Service Bulletin

Conversion of aircraft from CASA certificated FAR23 Amendment 45/48 status to CASA certificated FAR23 Amendment 54 status.

All GA8 aircraft serial numbers GA8-00-004 through GA8-03-025.

Document: Service Bulletin SB-GA8-2003-04

Figure 8-1 – Capacitor installation wiring

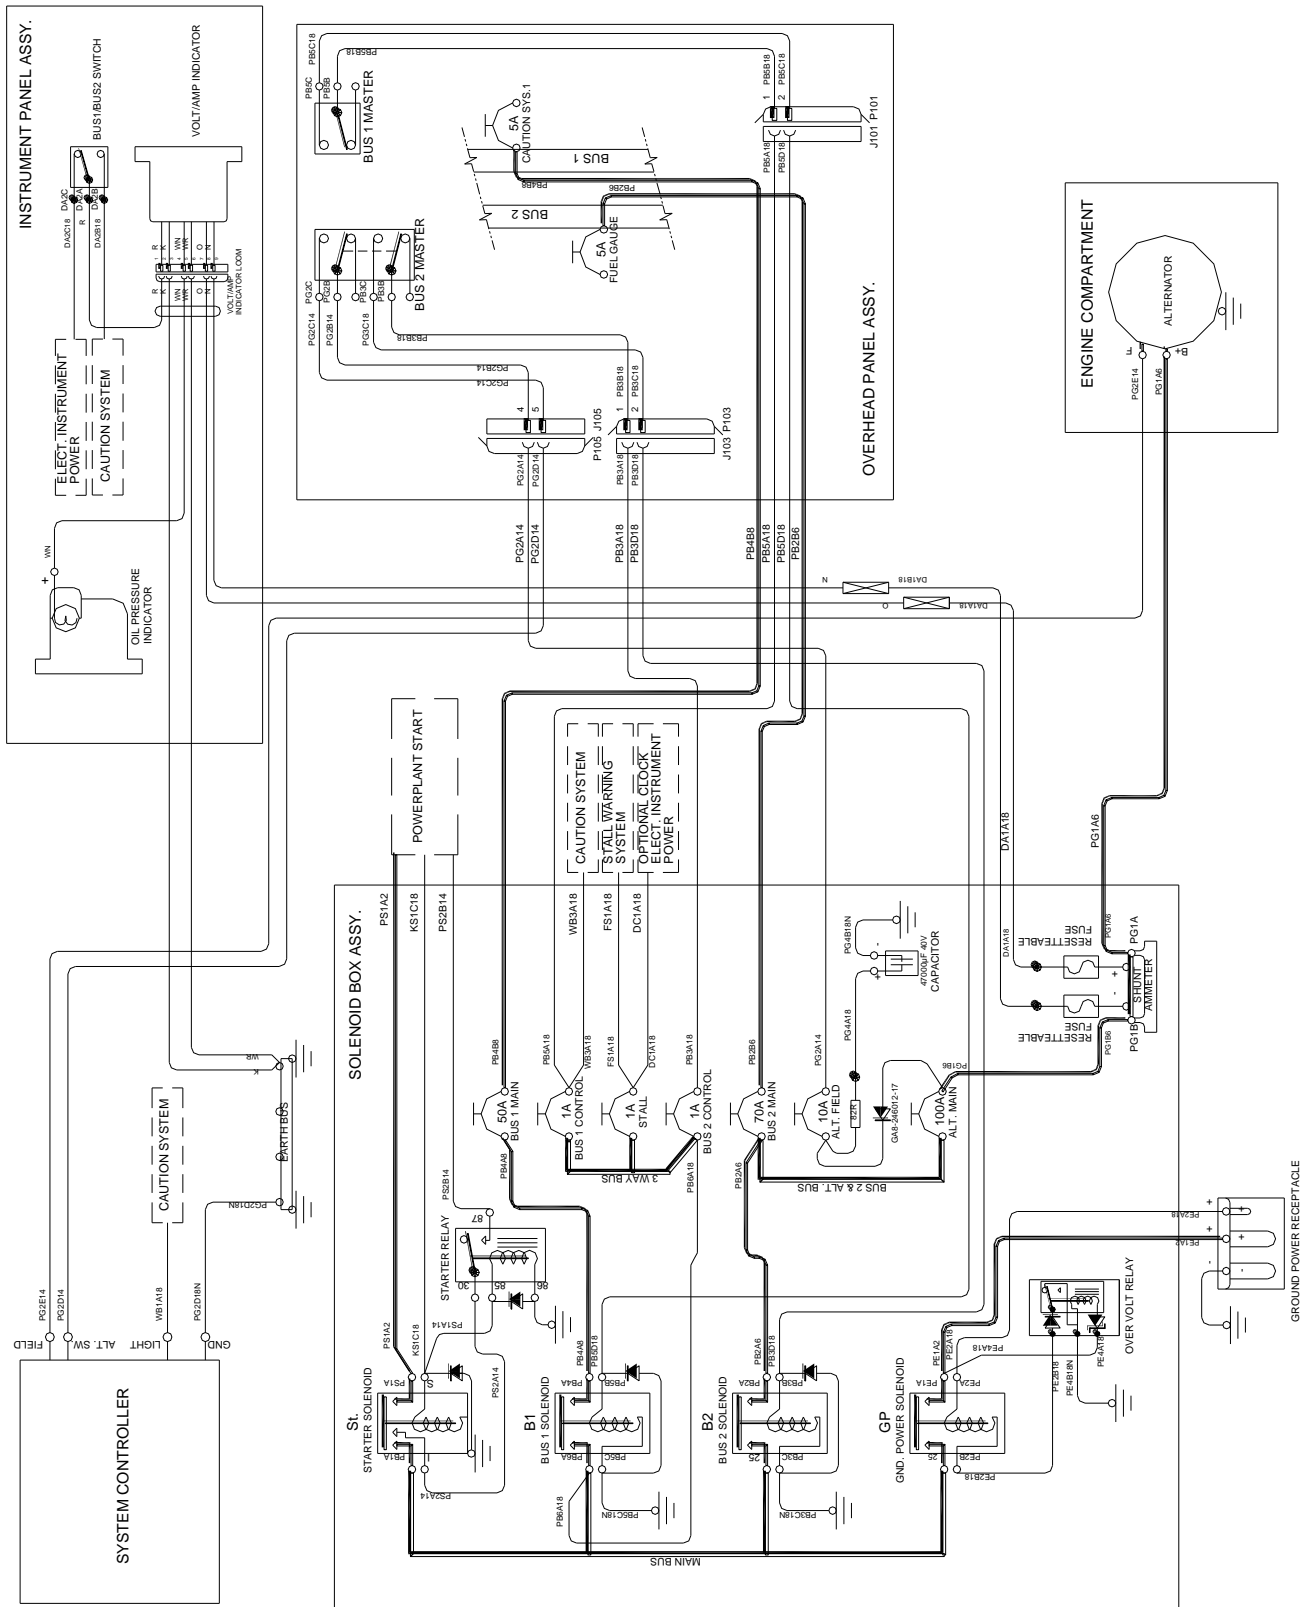
3. Replace main supply wire between the alternator main and alternator field circuit breakers with diode assembly (P/N GA8-246012-17). Ensure correct orientation of diode. Refer to Figure 8-1 for wiring schematic.

4. Install excitation resistor assembly (P/N GA8-246012-19) between the power supply side of the alternator field circuit breaker and the positive terminal of the capacitor. Refer to Figure 8-1 for wiring schematic.

6. Remove the existing Bus 2 master switch located in the overhead electrical panel assembly and replace with the new double pole double throw Bus 2 master switch (P/N MS35059-23). Re-connect existing wires PB3A18 and PB3B18 to terminals of the new switch. Refer to Figure 8-1 for wiring schematic.

7. Install and secure wire PG2A14 into the aircraft main wiring loom from the alternator field circuit breaker terminal to pin 4 of plug P105, and wire PG2B14 from pin 4 of socket J105 to terminal PG2B of newly installed Bus 2 master switch. Refer to Figure 8-1 for wiring schematic.

8. Install and secure wire PG2C14 into the aircraft main wiring loom from terminal PG2C of the newly installed Bus 2 master switch to pin 5 of socket J105, and wire PG2D14 from pin 5 of plug P105 to terminal ALT. SW. of the system controller (P/N GA200-243001-1). Refer to Figure 8-1 for wiring schematic.

Figure 9-1 – Existing static drain location

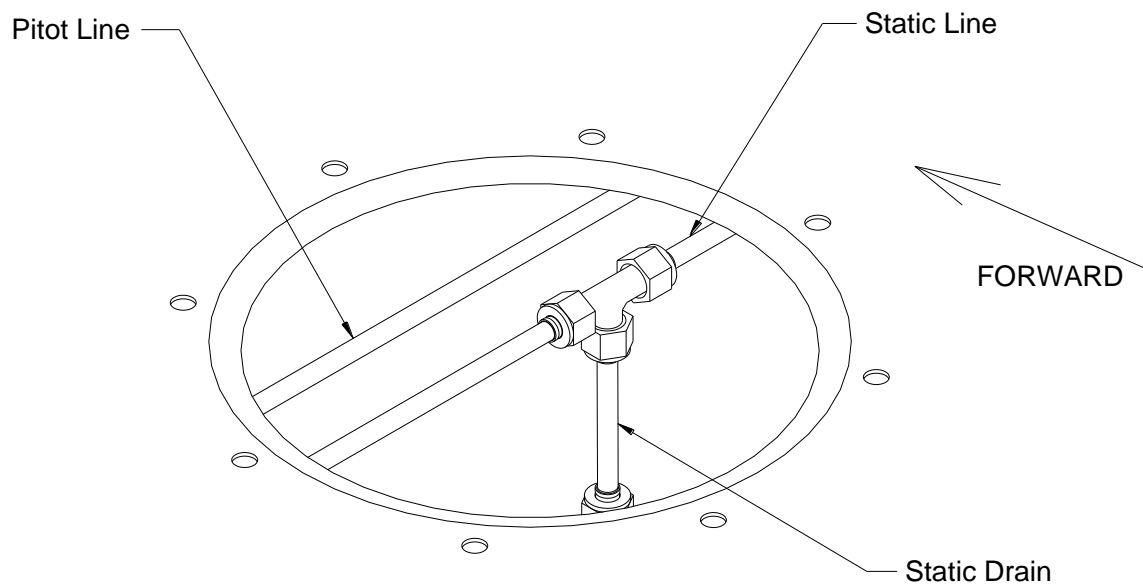
1. Gain access to the location of the existing static drain by removing the inspection panel positioned directly behind the pilot's seat.

Figure 9-2 – Pitot drain installation (S/N GA8-00-004 to GA8-02-019)

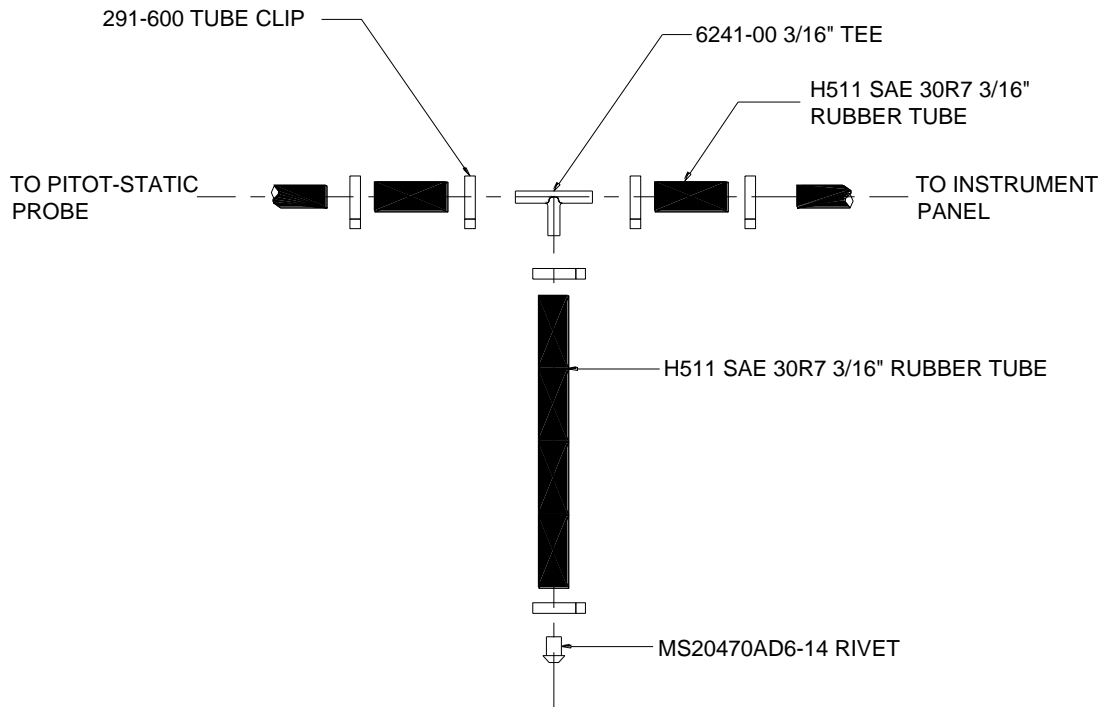
3. Cut the pitot line and install a drain line using a 6421-00 tee, 291-600 tube clips, H511 SAE 30R7 3/16" rubber hose and an MS20470AD6-14 rivet. Refer to Figure 9-2.

Figure 9-3 – Pitot drain installation (S/N GA8-02-020)

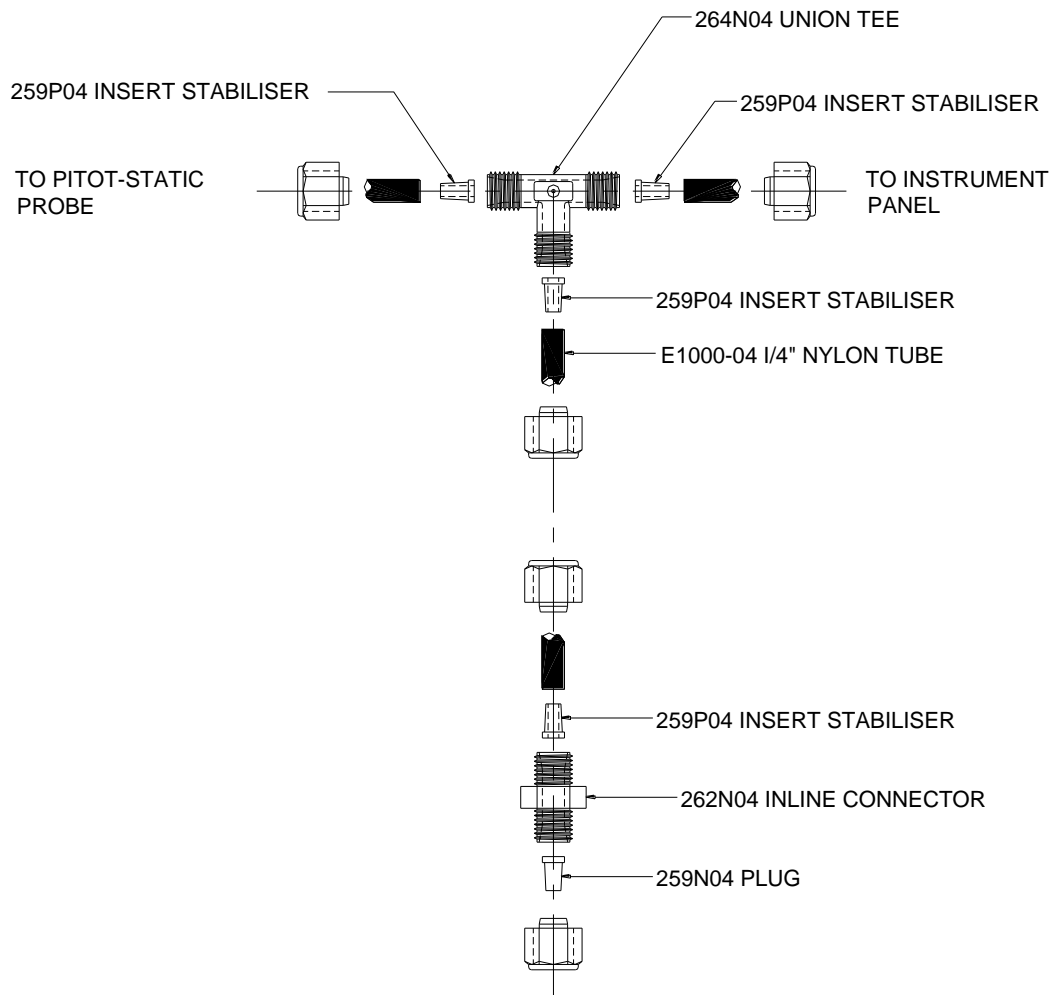
3. Cut the pitot line and install a drain line using a 264N04 union tee, 259N04 insert stabilisers, 262N04 inline connector, 259N04 plug and E1000-04 ¼ NS nylon hose. Refer to Figure 9-3.
